# Laney

**Service Diagrams**

DRAWN	R.J.F
DATE	11/03/97
TITLE	PA Head Mic/Line Channel
DRW. NO.	PCB 9111

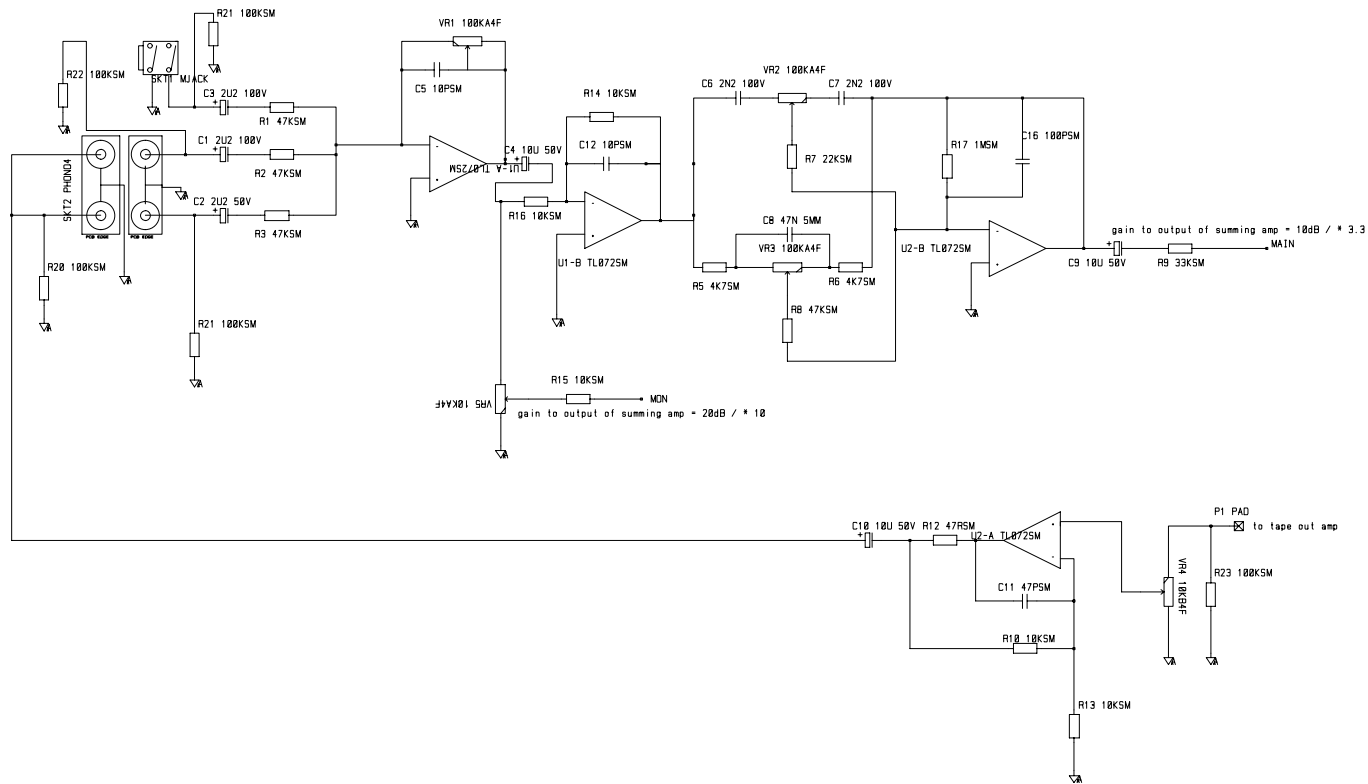
ISSUE	USED IN	issue two 2/01/97	issue three 11/03/97	ISSUE FOUR 25/8/98	
TYPE	CR300 P707S CR400 P707SR	C3 = 0PR CUT TRACK BETWEEN C1 + C3 CUT TRACK BETWEEN C3 + C4 (C2 SIDE) LINK UNCONNECTED PAD OF C1 TO TO UNCONNECTED PAD OF R1	issue two modifications corrected	C4 ADDED SEE CHANGE NOTE 171

DRAWN	R.J.F
DATE	11/03/97
TITLE	9 BAND MONO GRAPHIC
DRW. NO.	PCB 9113

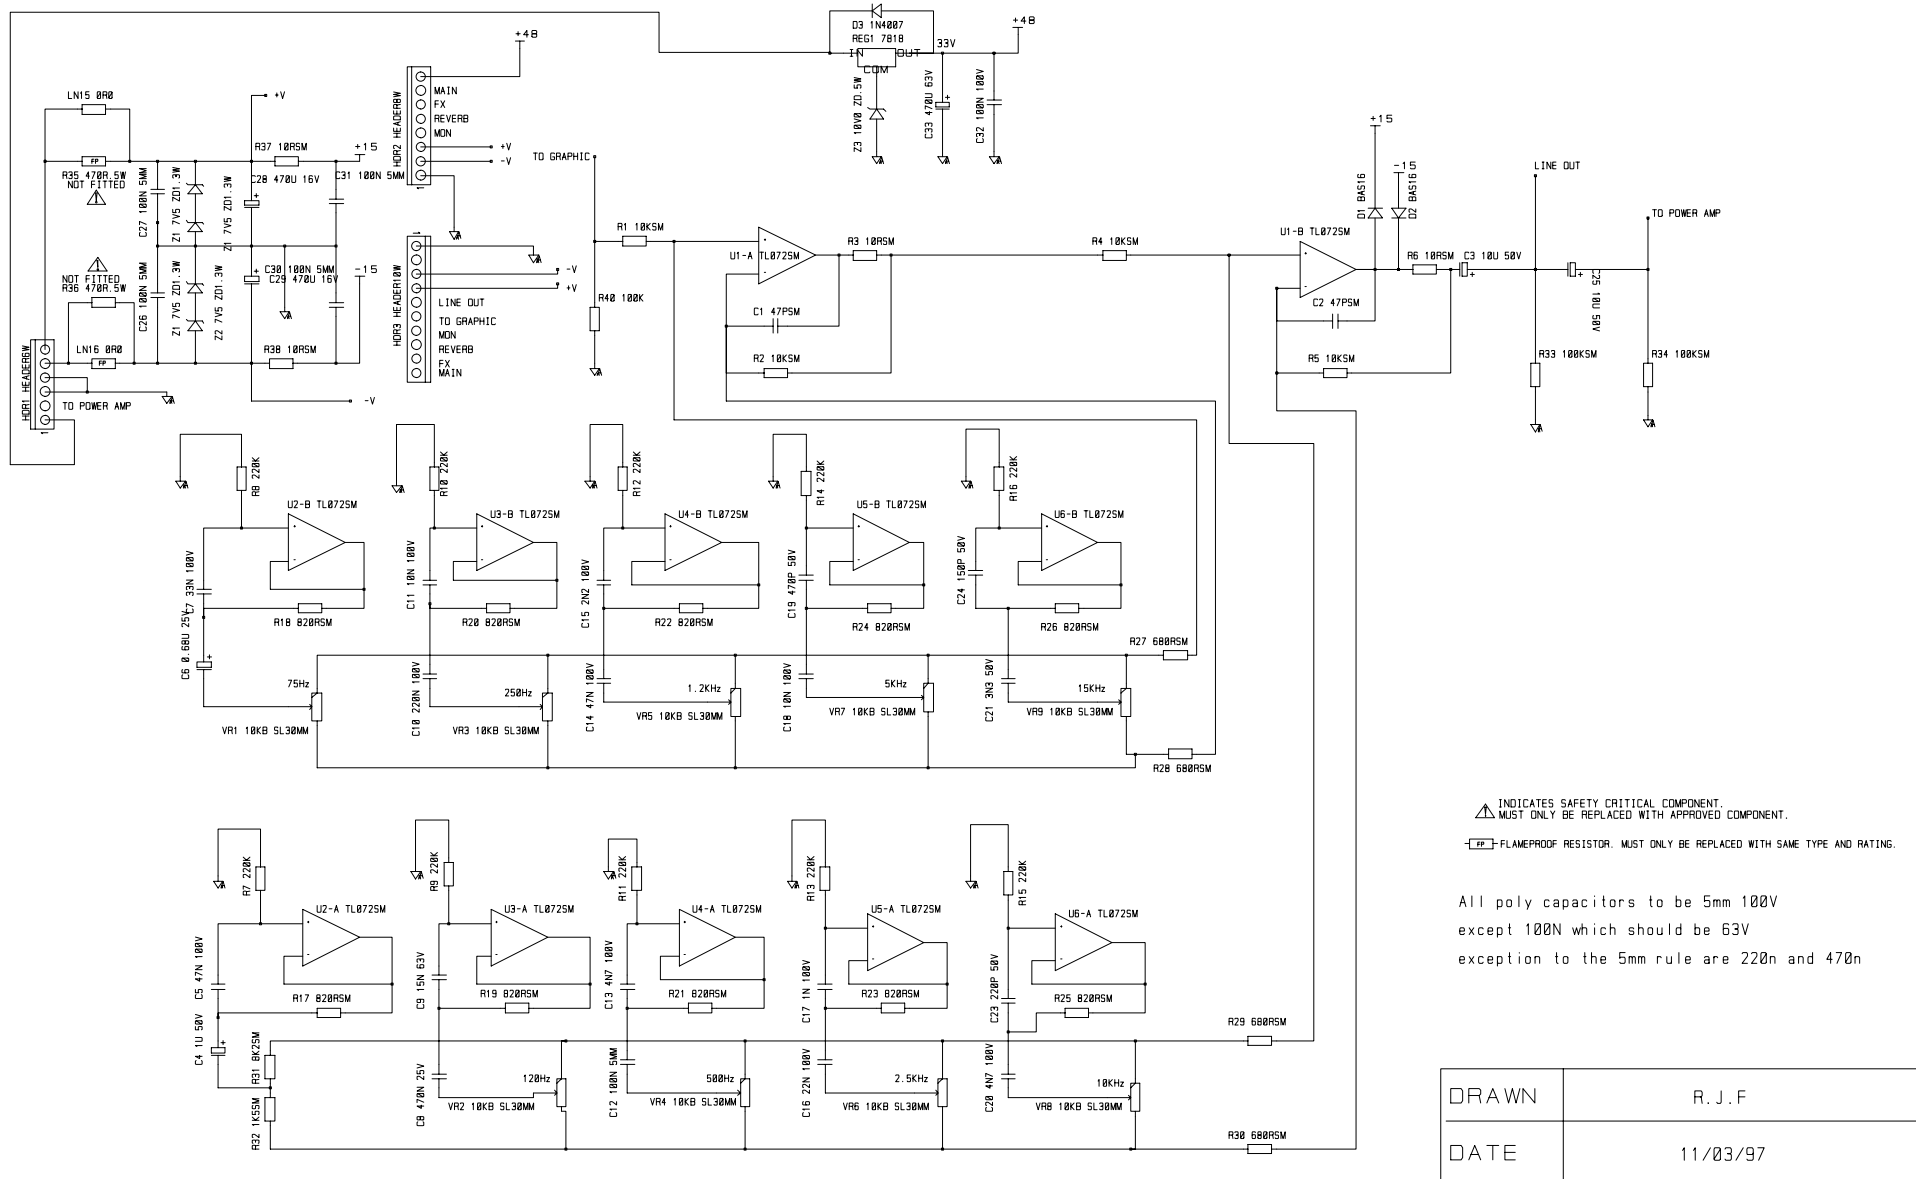
ISSUE	USED IN	issue two 28/01/97	issue three 11/03/97
TYPE	CR300 P7075 CR400 P7075R	R1 needs grounding via a 100K	R1 GROUNDED VIA 100K (R40) DROPPER RESISTORS MOVED TO OUTPUT BOARD, LN15 + 16 FOR BYPASS

DRAWN	R. J. F
DATE	11/03/97
TITLE	300W OUTPUT MODULE
DRW. NO.	9121_4

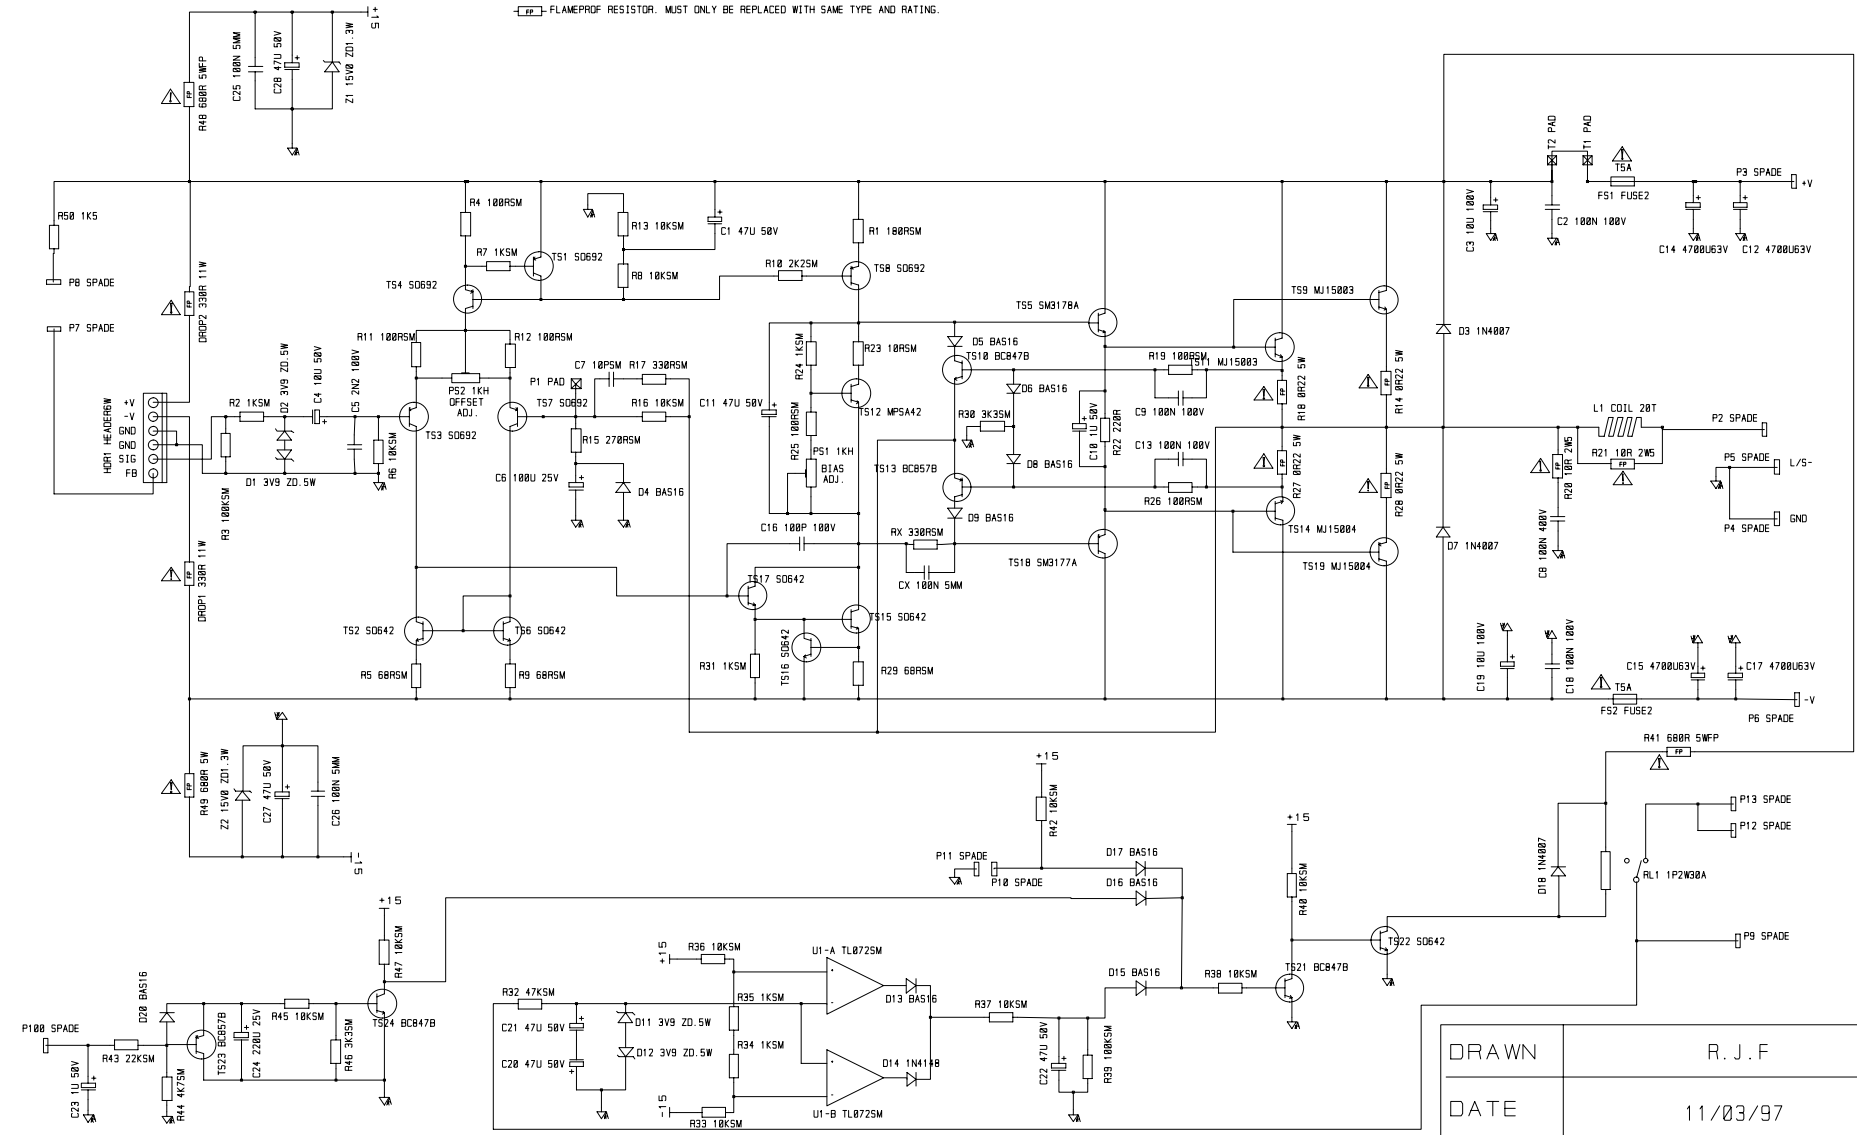
ISSUE	ISSUE FOUR 11/3/97	28/09/99			
TYPE	330R 11W FP H. T. DROPPER RESISTORS ADDED PHANTOM POWER H. T. DROPPERS ADDED	Rx and Cx added to reduce short circuit current.
